ADDENDUM NO. 2

DATE OF ISSUANCE:	April 22, 2024
PROJECT:	2024 Addition and Renovations North Harrison Elementary School 1115 W. Whiskey Run Road Ramsey, IN 47166
OWNER:	North Harrison Community Schools
ARCHITECT'S PROJECT NO.:	23-228.001
ORIGINAL BID ISSUE DATE:	April 03, 2024

ISSUED FOR: Public Bidding Addendum #2
DATE: 04-03-2024 / 04-22-2024

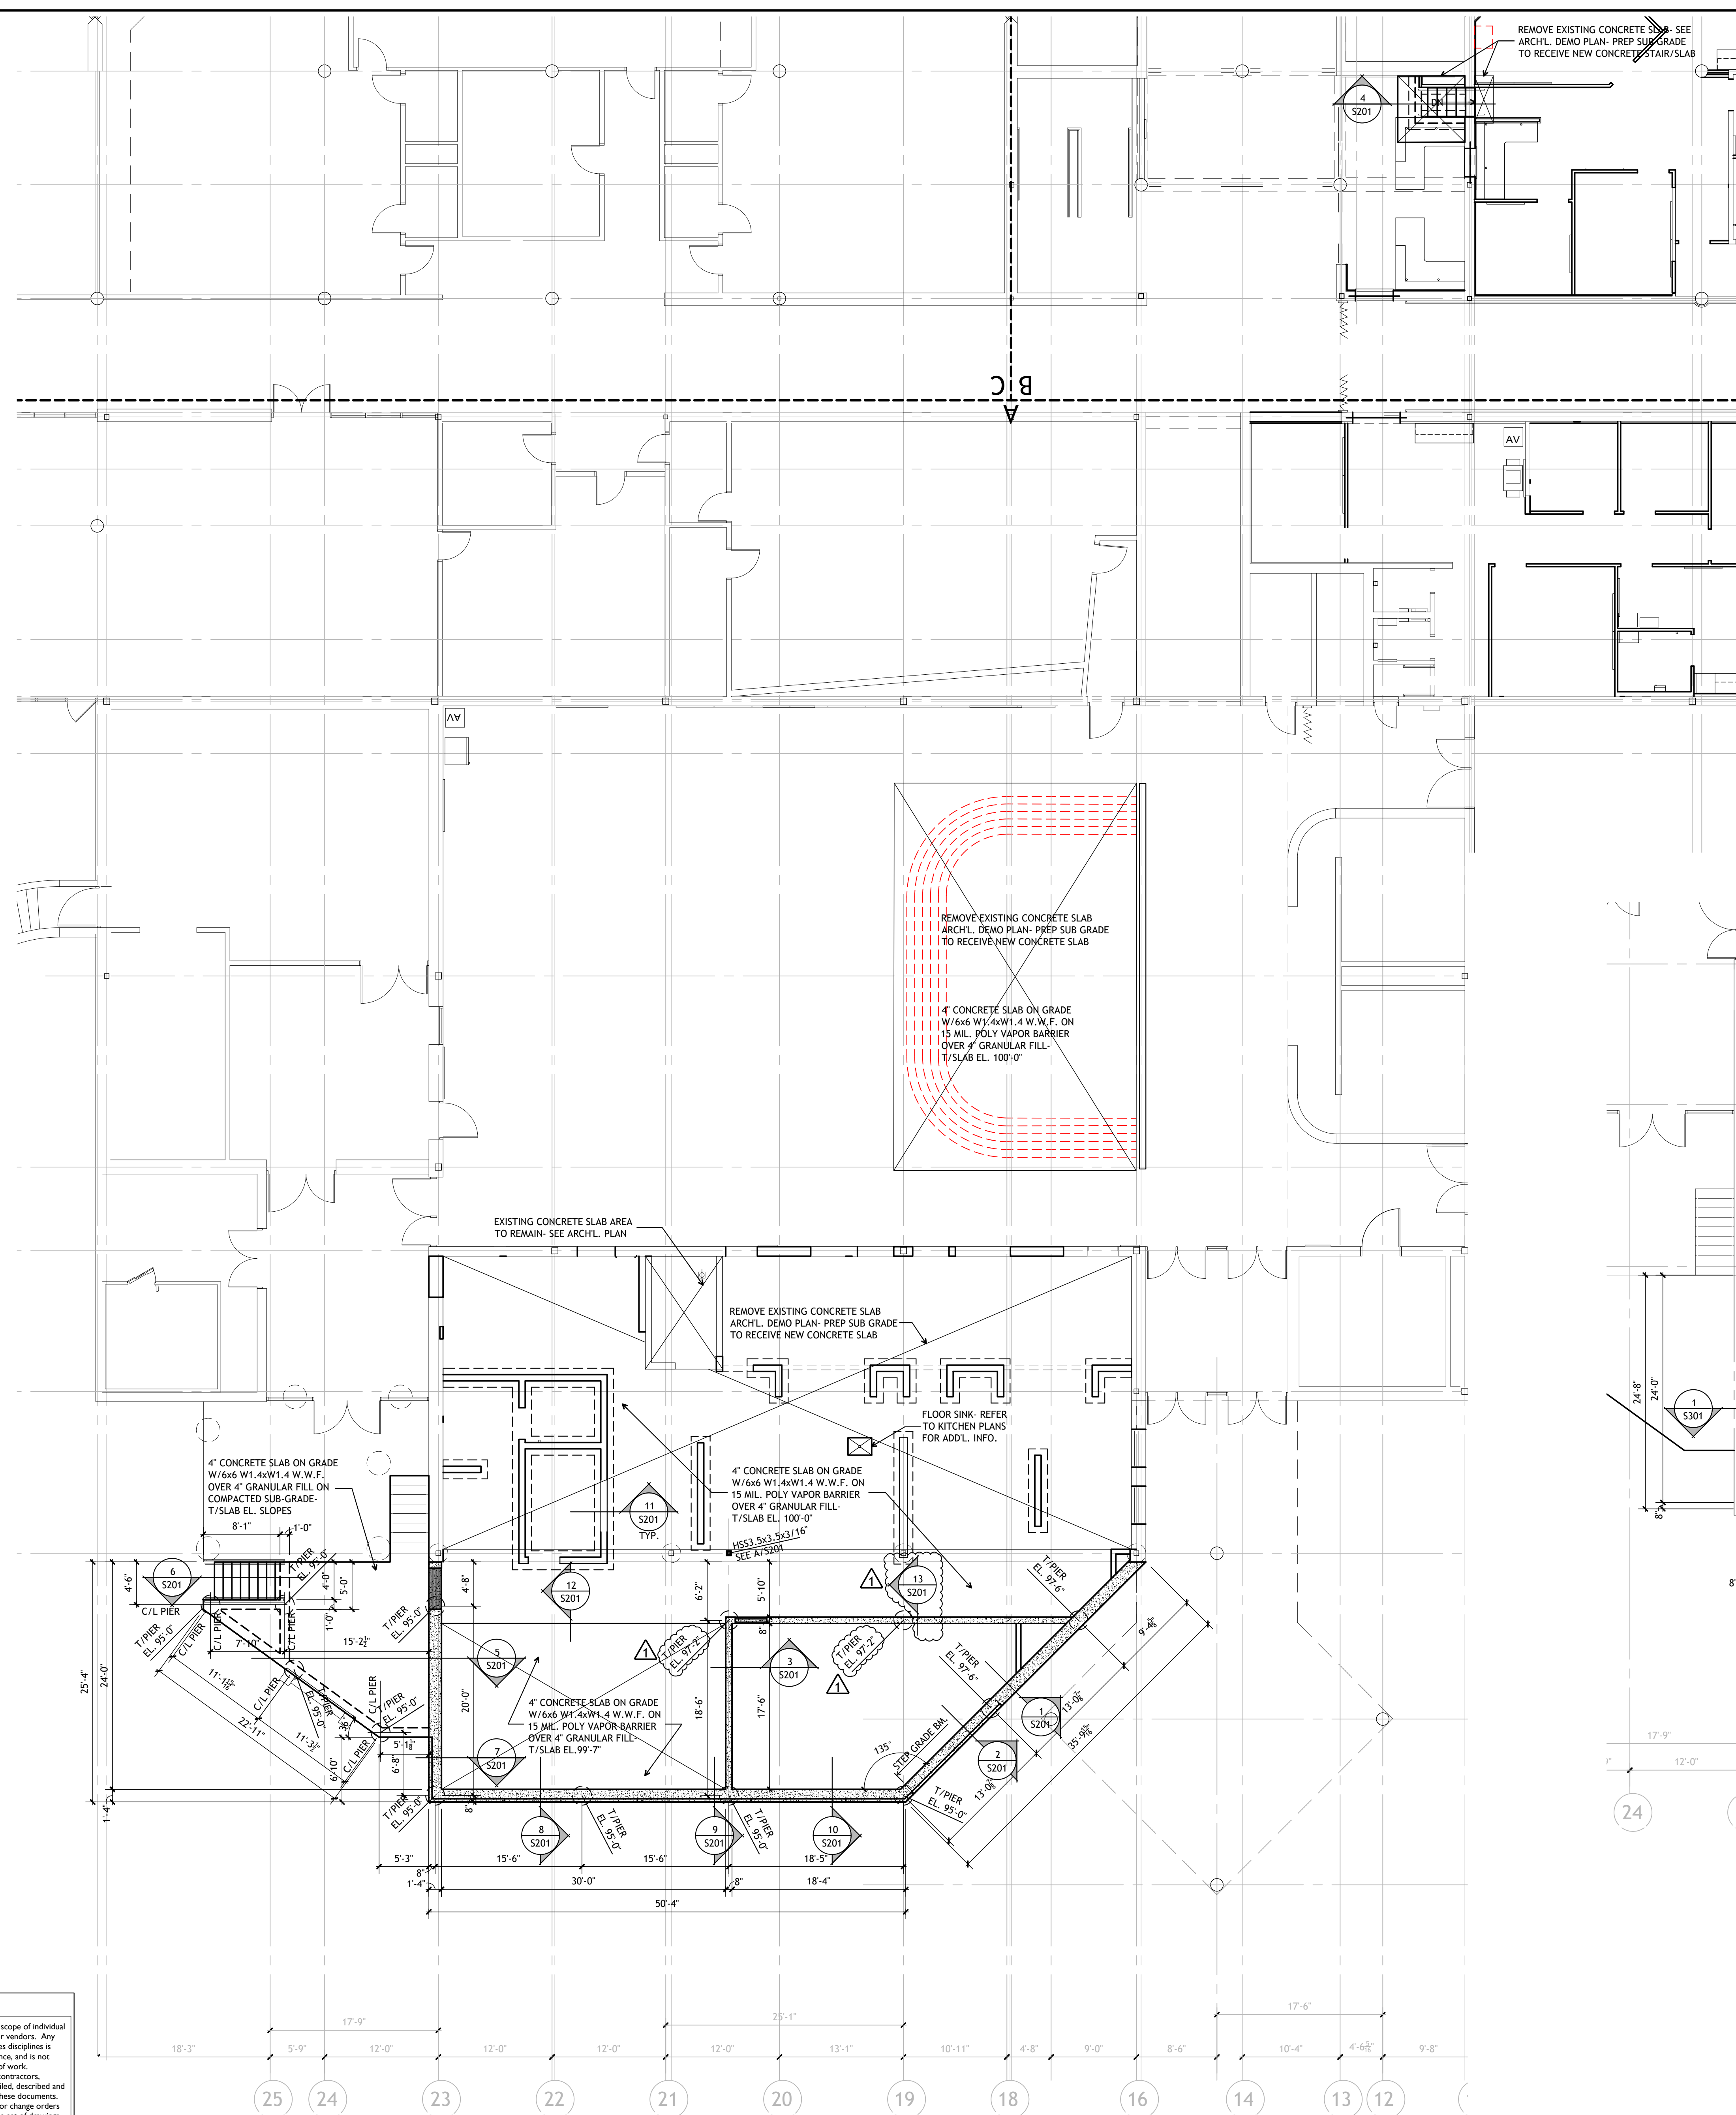
4. Contractor to provide a storage container for the duration of the project to secure Owner's existing kitchen equipment to be re-installed in the new kitchen. See attached Drawing AD-2A for tentative location and additional requirements.

SHEET NUMBER
A 702
23-228.001

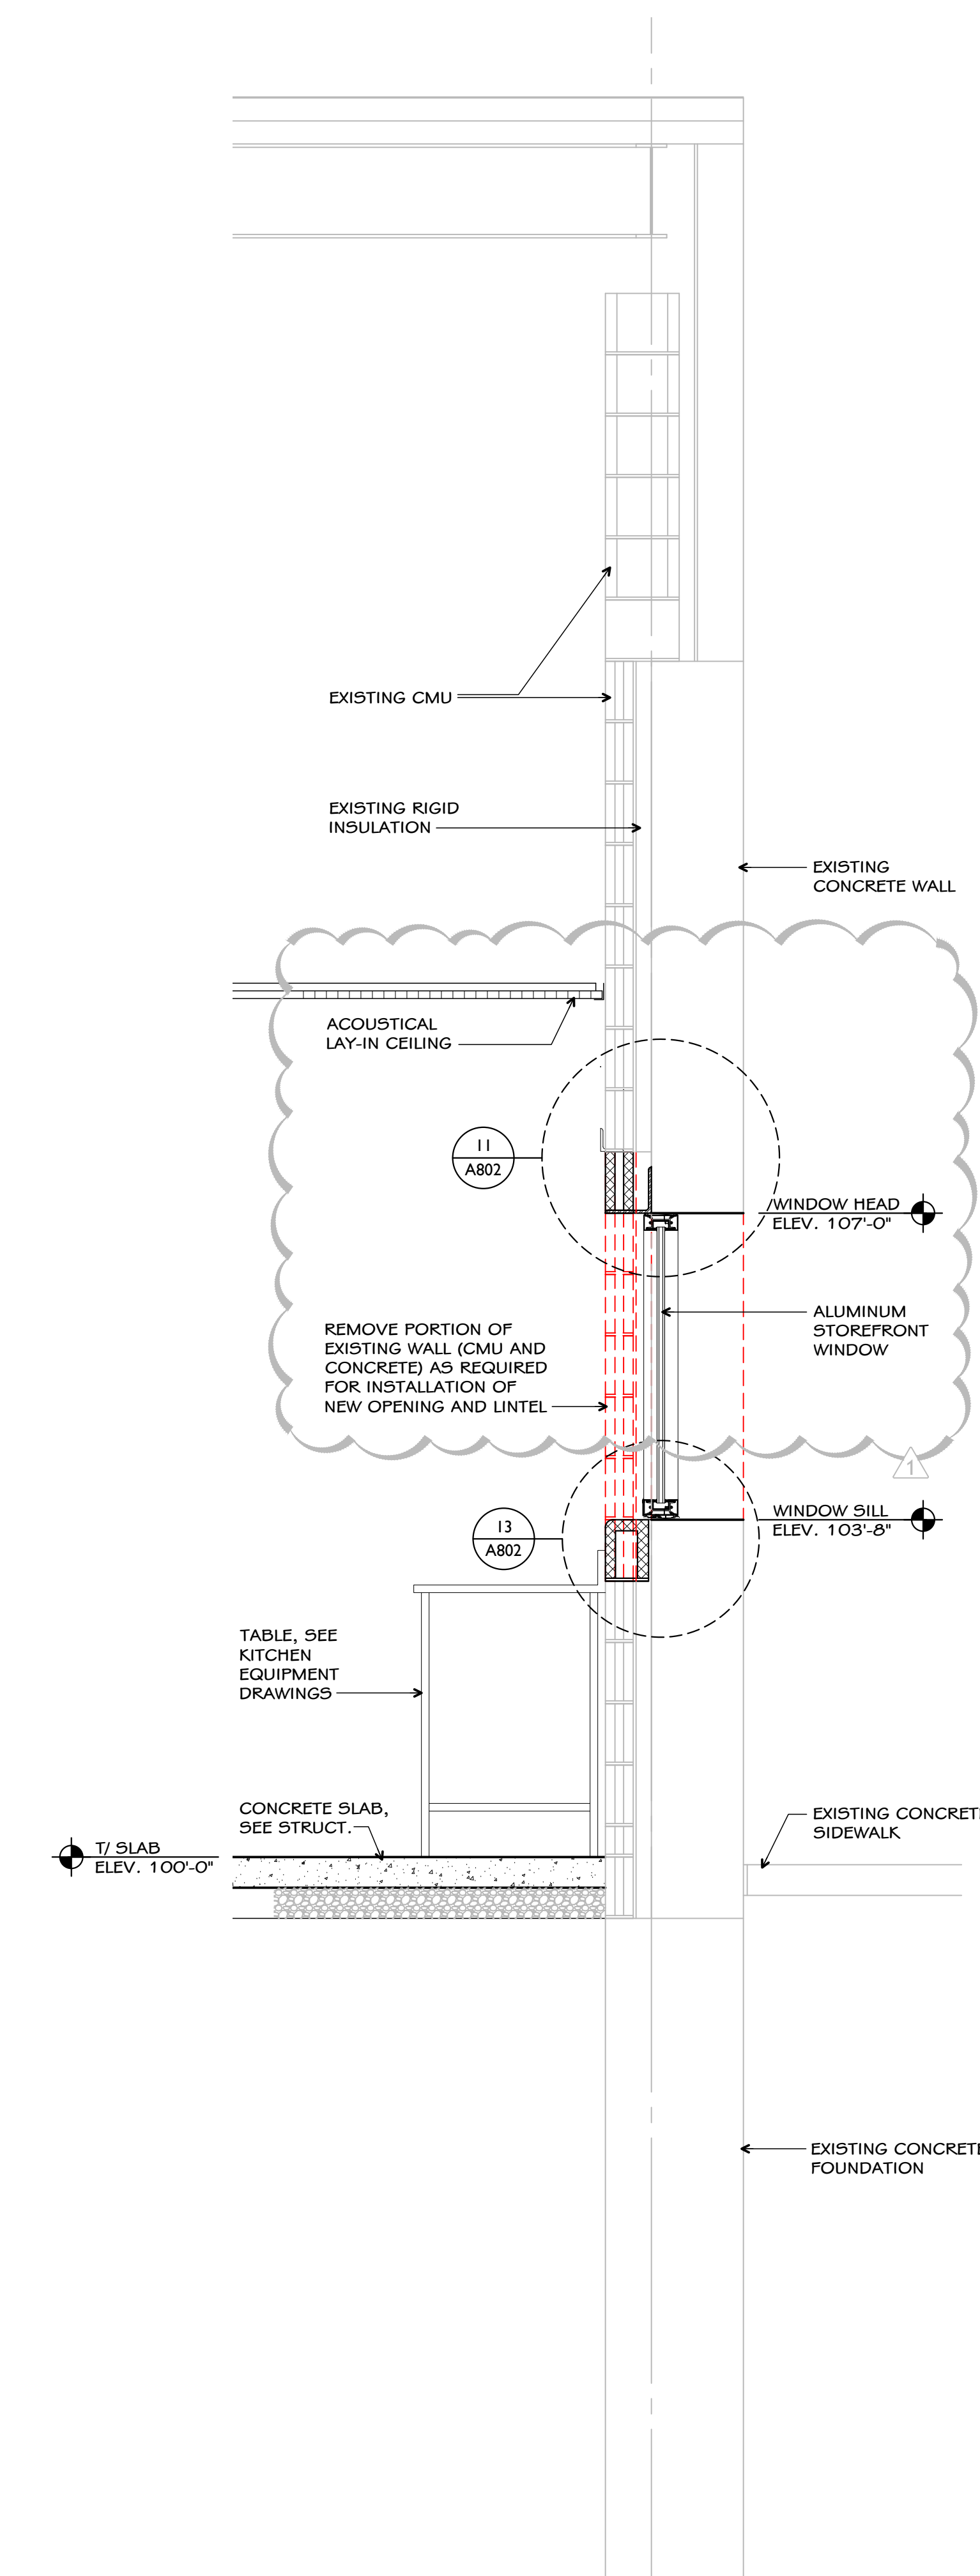
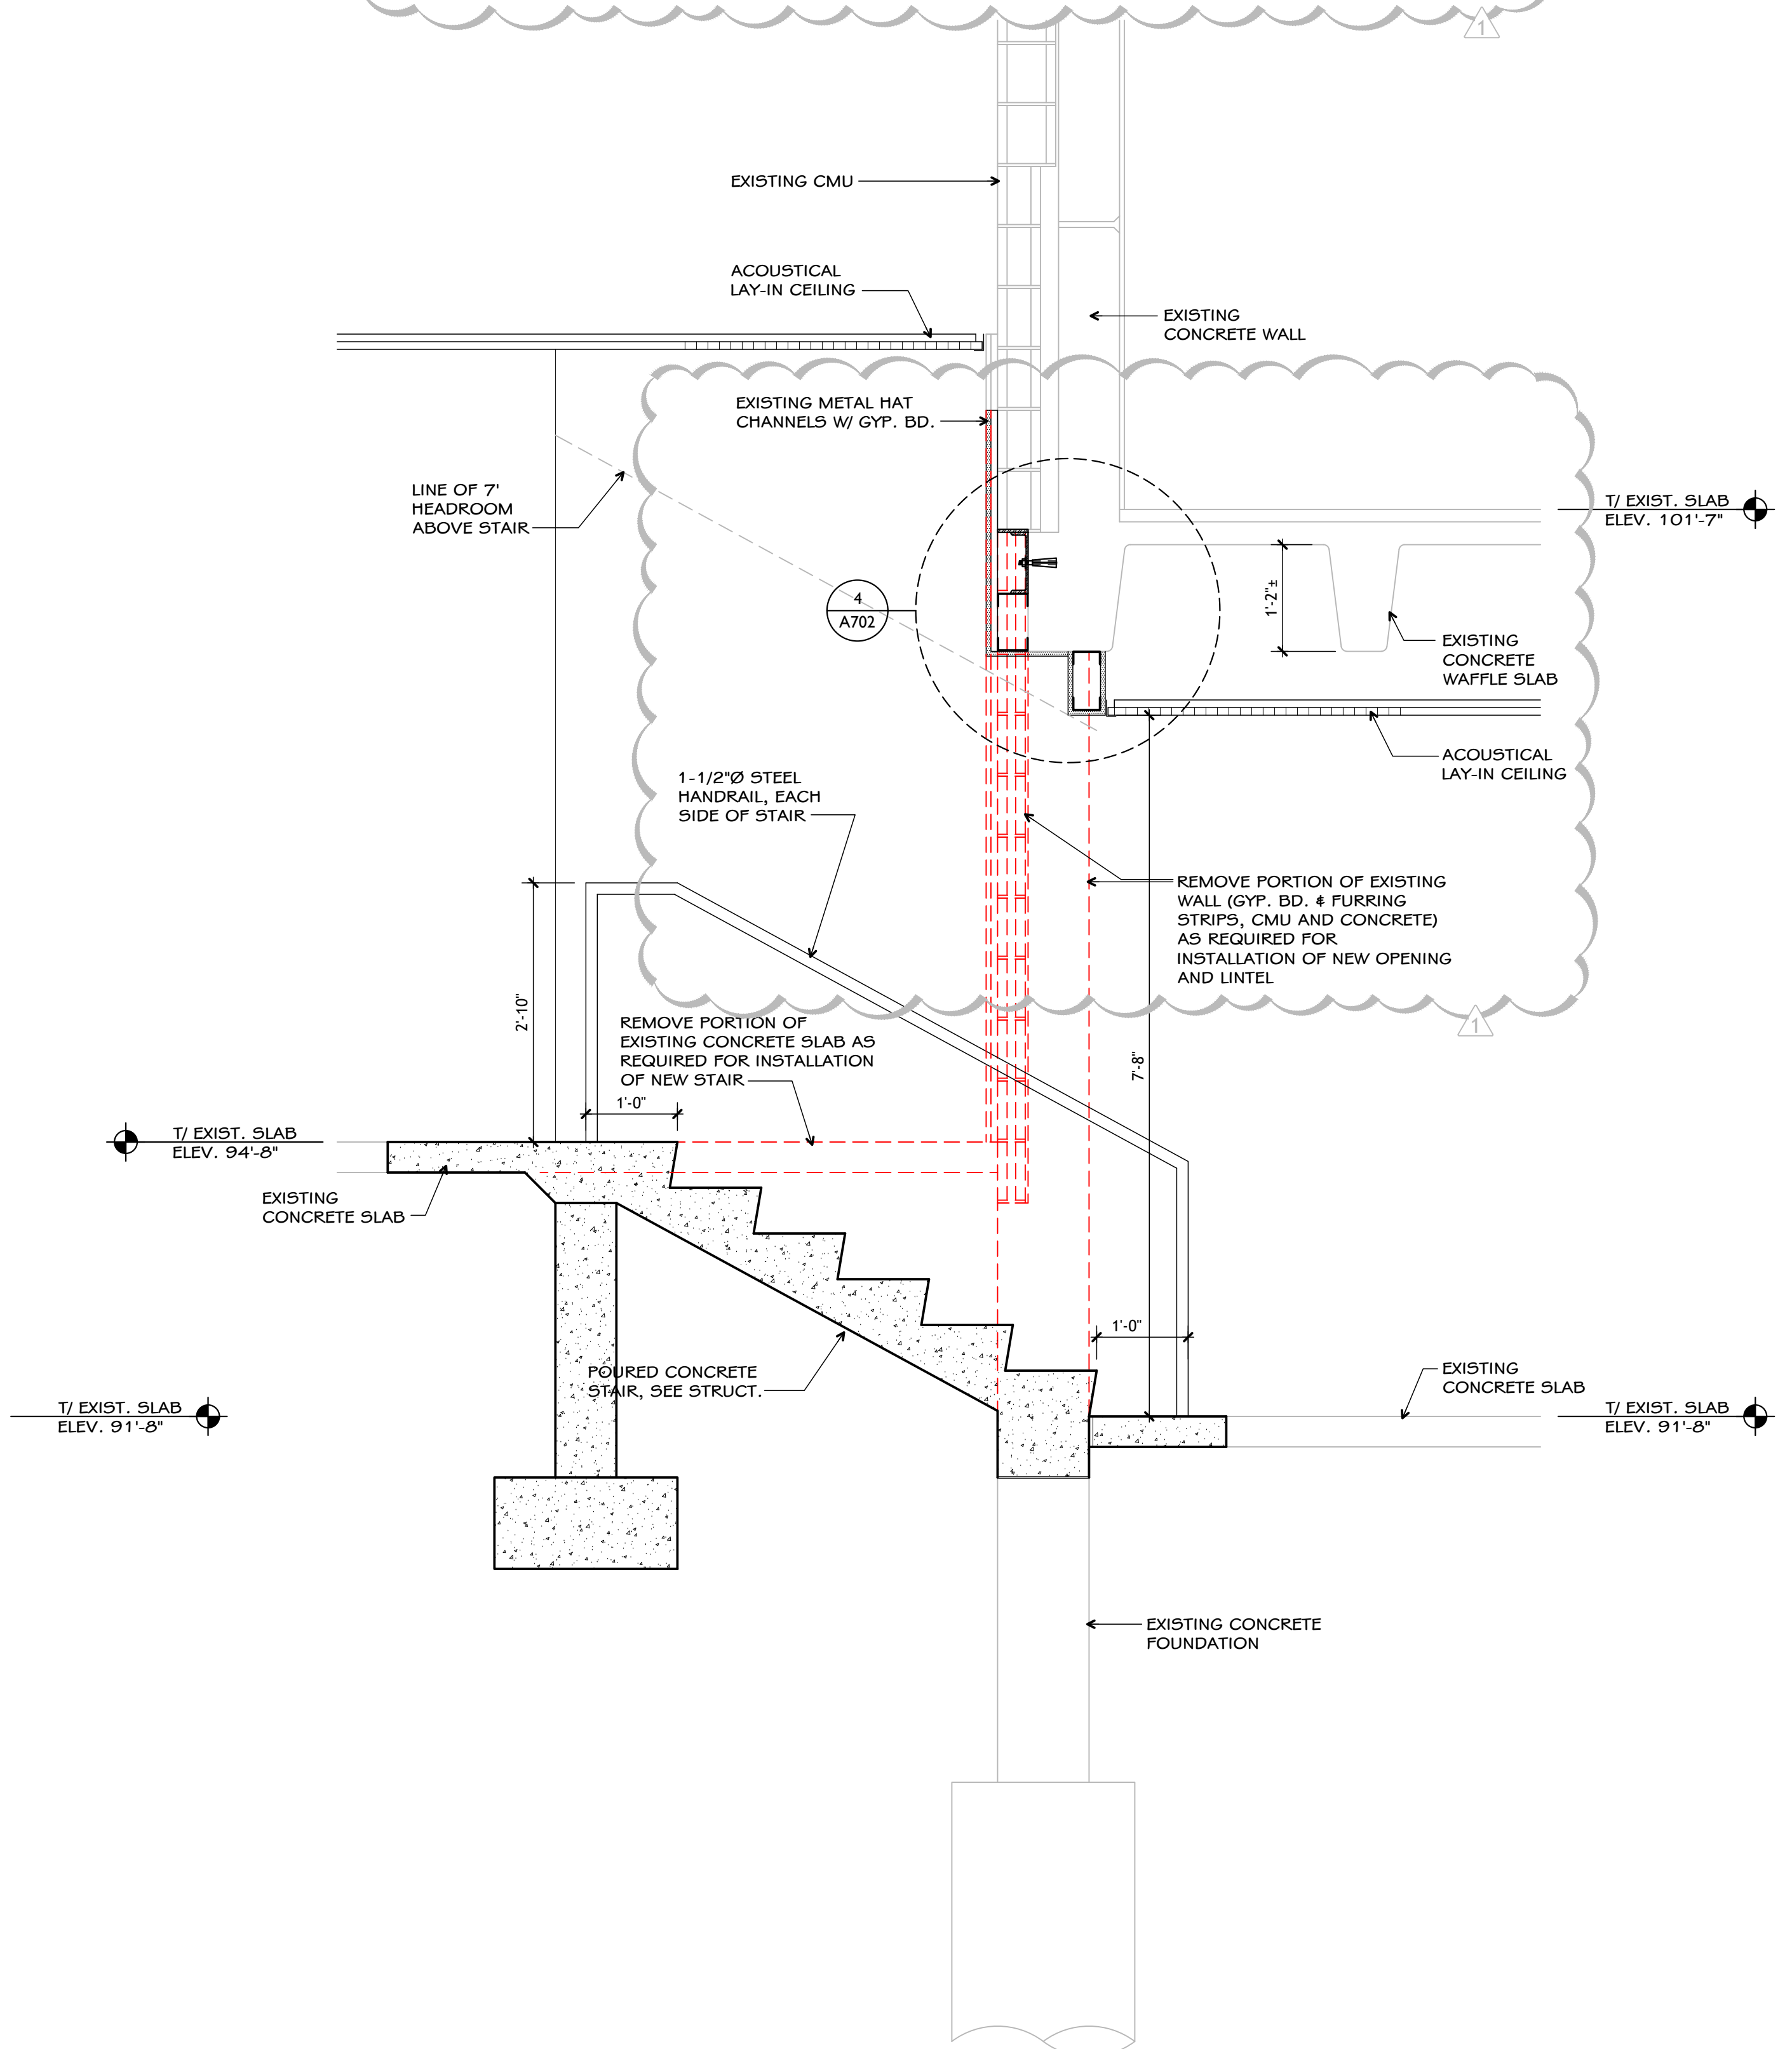
Replace with attached revised Drawing in its entirety; revisions have been clouded for reference. Details added for lintels at openings through existing walls.
